Addendum Report 1

Application ID: LA04/2022/0118/F	Date of Committee: 17 th October 2023
Proposal: The proposed erection of 46No.apartment units of traditional construction over three story's, with associated car parking site and landscaping works and the alteration of an existing vehicular access. (Amended plans received 21.9.23)	Location: 146 Parkgate Avenue Strandtown Belfast BT4 1JD.
Referral Route: Paragraph 3.8.2 (a) (i) of the Scheme of Delegation (proposal of more than 12 units with the original recommendation to refuse and representations in support).	
Recommendation: Approval subject to conditions and s76 planning agreement	
Applicant Name and Address: Parkgate Property Developments Ltd 17 Mound Road Dromore BT25 1DL	Agent Name and Address: Rolston Architects 49 Lisleen Road Belfast BT5 7SU
Addendum Report: Background <ol style="list-style-type: none">1. This application was previously reported to the 29th June 2023 Planning Committee. The application was deferred so that <i>'further engagement takes place between officers and applicant to attempt to resolve the issues. The Committee also agreed to hold a Committee Site Visit.'</i>2. Two sets of amended plans have been s

Amended Site Layout:

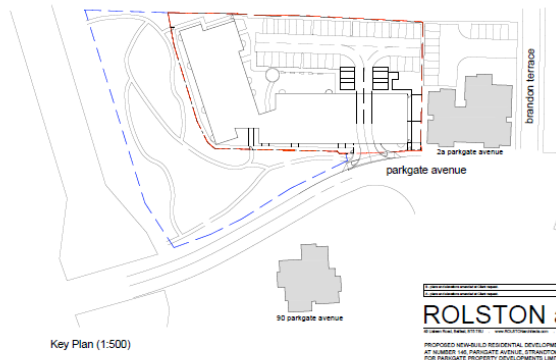
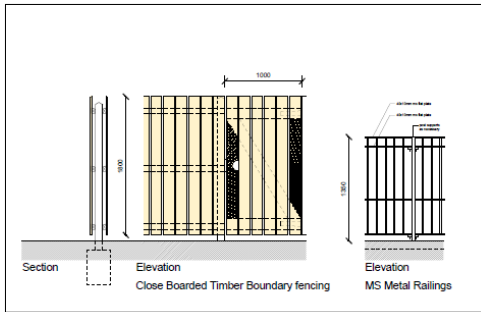
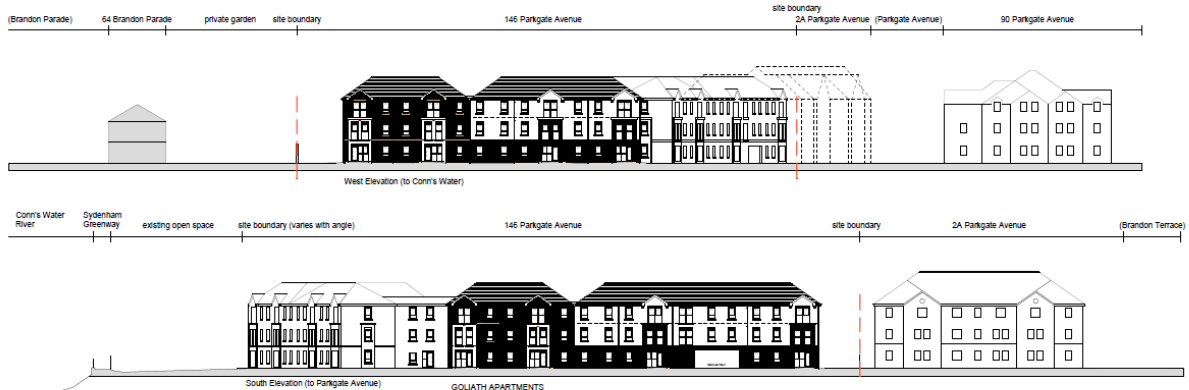
9. The applicant has amended the design of the proposed apartments, introducing hipped roofs and a greater variety of materials (render and brick rather than all render). The western block has also been repositioned approximately 2 metres westwards.

11. Following the repositioning of the western block and introduction of oriel windows to restrict views, the building is now considered to be adequately separated from existing houses along Brandon Parade. These changes have improved overall amenity of future tenants and existing residents.

19. The western block has been moved approximately 2 metres to the west. This increases the available communal amenity space within the central portion of the site by 66 sqm to 400 sqm. This moderately improves the quality of amenity space within the development, maintaining over 10% open space on the site (total of 931 sqm). However, criticism of the useability of this space remains.

Figure 1 – Breakdown of areas of communal open space around proposed apartment building with access by residents only.

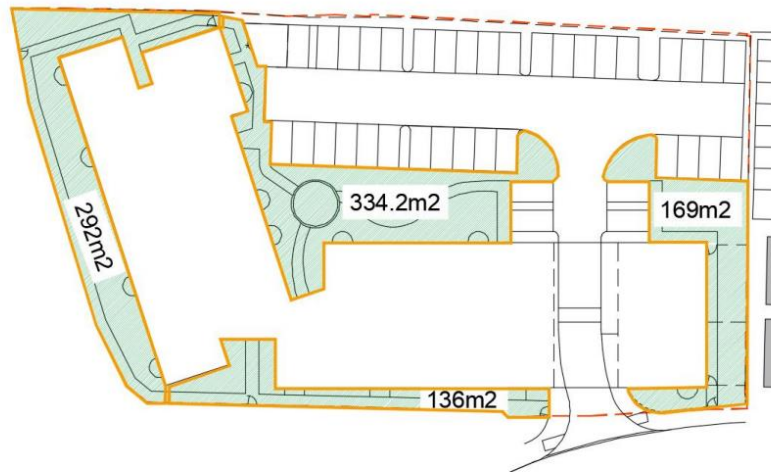
The agent indicated on a site layout plan that 931sqm of communal open space has been provided within the site as illustrated in the first image below (Image 1). The agent later claimed that 1,993sqm of open space was being offered through the development (Image 2). This included car parking areas and is not considered to be an accurate reflection of the quantum of communal open space. A figure of approximately 931sqm of communal open space is considered to be accurate.

The primary open space area is located to the rear of the apartment buildings. There are several additional smaller pockets of amenity space to the front and sides of the buildings. However, when examining the quality of the provision it is evident that there are concerns with the quality and typology of amenity space. Pockets of amenity space are dotted across the site. Whilst they offer visual relief, other than two areas to the rear marked as 334sqm and 169sqm they are limited in quality and usability. In addition, the figures are inaccurate as they include pathways into and around the development and cycle parking areas. Amenity space is required to provide for passive recreational activity such as sitting out, for active recreational activity and should be adequate as play space for children. Amenity space should be of a shape and size which can practically accommodate the activities for which they are intended and should be practical and level where possible and designed in

accordance with Creating Places Supplementary Planning Guidance. Amenity areas are either too small and narrow or located in areas which would be completely overshadowed such as the space located between the Goliath apartments and 2a Brandon Terrace. This area will be hemmed in by the two adjacent buildings which doesn't represent a quality design.

Fig.5 – site plan – open space comparison with neighbouring development.

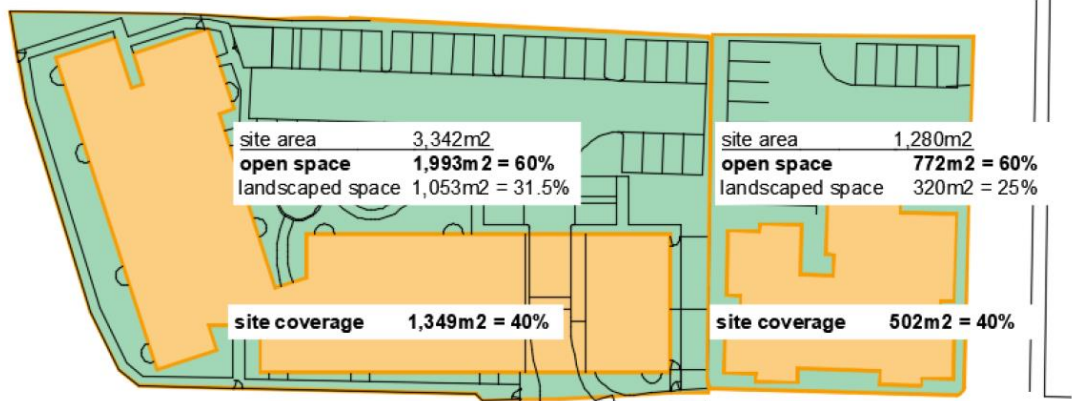
6.36	A significant number of areas identified as amenity act as landscape buffers softening the boundaries and parking areas as opposed to functioning as areas of communal private space. In essence the quantum and quality of space is poor and represents overdevelopment of the site. Private amenity space within the site is limited to a number of ground floor units and no dedicated provision is included for apartments at first and second floor.
